Subject: GCPP23-0001/ SUBFY2023-0001
207 E 45th Street (Parcels R2734500592 & R2734500593)
Mod Court Townhomes Subdivision

The applicant is requesting approval of a subdivision application to allow for the development of a 23-lot residential subdivision, consisting of 22-new single-family attached townhome units and 1 common lot on 1.38 acres. The existing home and out buildings are proposed to be removed.

SITE PLAN

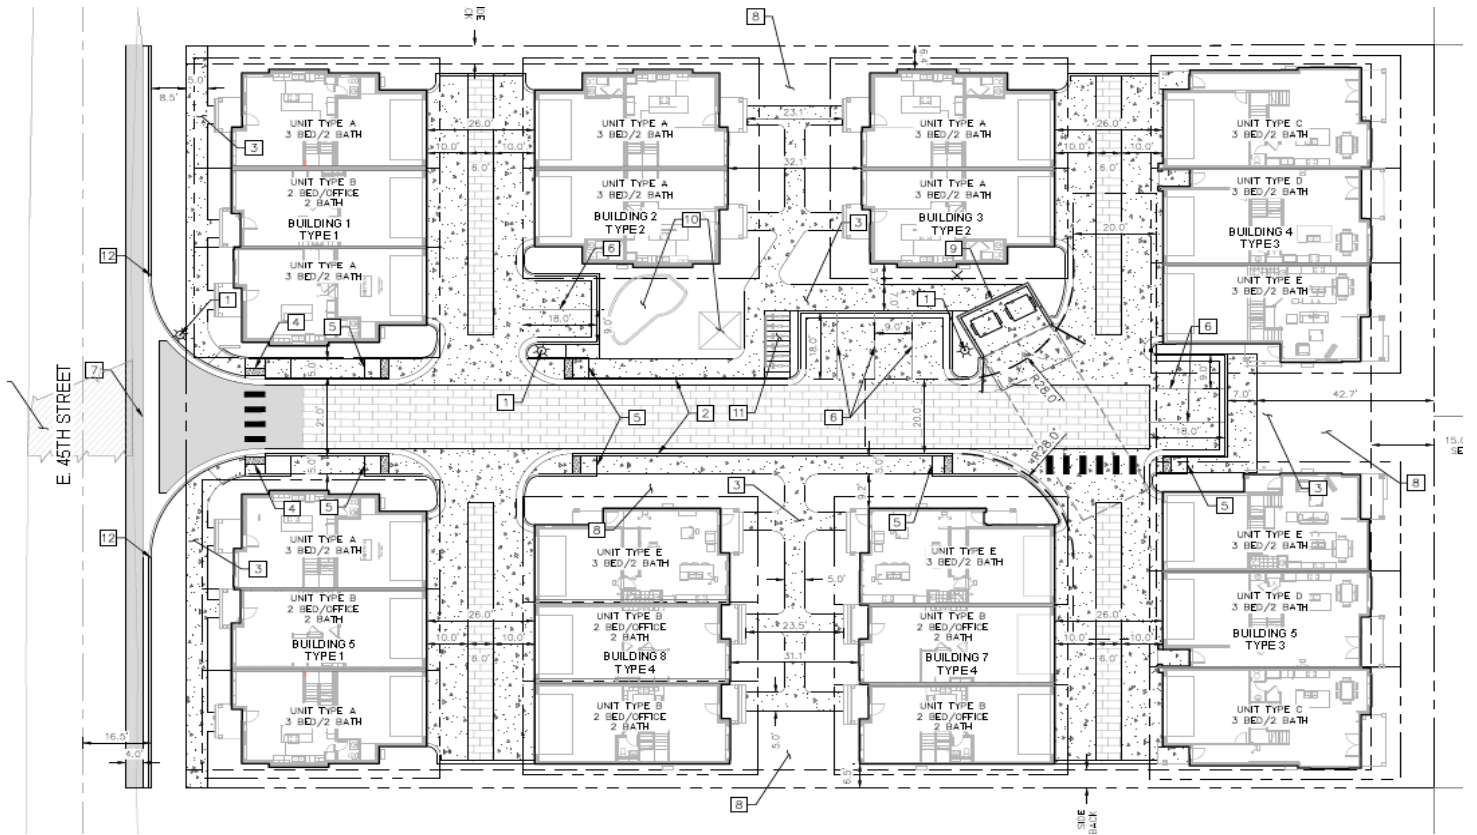
- c. **Applicant's Proposal:** The applicant has proposed to construct 45th Street as half of 33-foot local street section with pavement widening total 16.5-feet from the centerline, 4' wide parking stripe, vertical curb, gutter, 8-foot wide planter strip and 5-foot wide detached concrete sidewalk within the existing 50-feet of right-of-way.
- d. **Staff Comments/Recommendations:** The applicant's proposal meets District policy with the exception of the 4' wide parking stripe. As defined dedicated on-street parking is not allowed on local streets.

If street trees are desired, then an 8-foot wide planter strip should be provided. If the sidewalk is located behind the existing right-of-way line, the applicant should provide a sidewalk easement.

- c. **Applicant's Proposal:** The applicant is proposing to close the existing 10-foot wide unimproved curb cut type driveway located at site's northwest property line with pavement widening, vertical curb, gutter, 8-foot wide planter strip and 5-foot wide detached concrete sidewalk.

The applicant is proposing to construct a new 20-foot wide shared curb return type driveway located 907-feet north of Chinden Blvd.

The applicant is proposing permeable pavers within the driveway, located outside of the right-of-way.

- d. **Staff Comments/Recommendations:** The applicant's proposal to close the existing driveway onto 45th Street meets District policy and should be approved as proposed.

The proposed location and width of the new driveway and the proposed permeable pavers within the driveway, located outside of the right-of-way meets District policy, and should be approved as proposed.

The pavers are not allowed within ACHD right-of-way.

1. Improve 45th Street as half of a 33-foot wide local street section with pavement widening, vertical curb, gutter, and a 5-foot wide attached or detached concrete sidewalk abutting the site. If street trees are desired, then an 8-foot wide planter strip should be provided.

2. Provide a permanent right-of-way easement to 2-feet behind back of sidewalk for any sidewalk placed outside of the dedicated right-of-way.
3. Close the existing 10-foot wide unpaved driveway from the site onto 45th Street located 812-feet north east of of State Highway 20/26/ Chinden Blvd. with pavement widening, curb, gutter, and 5-foot wide attached or detached concrete sidewalk abutting the site.

4. Construct a 20-foot wide driveway onto 45th Street located 907-feet north of State Highway 20/26/ Chinden Blvd. Locate the permeable pavers as proposed within the driveway, outside of the right-of-way.
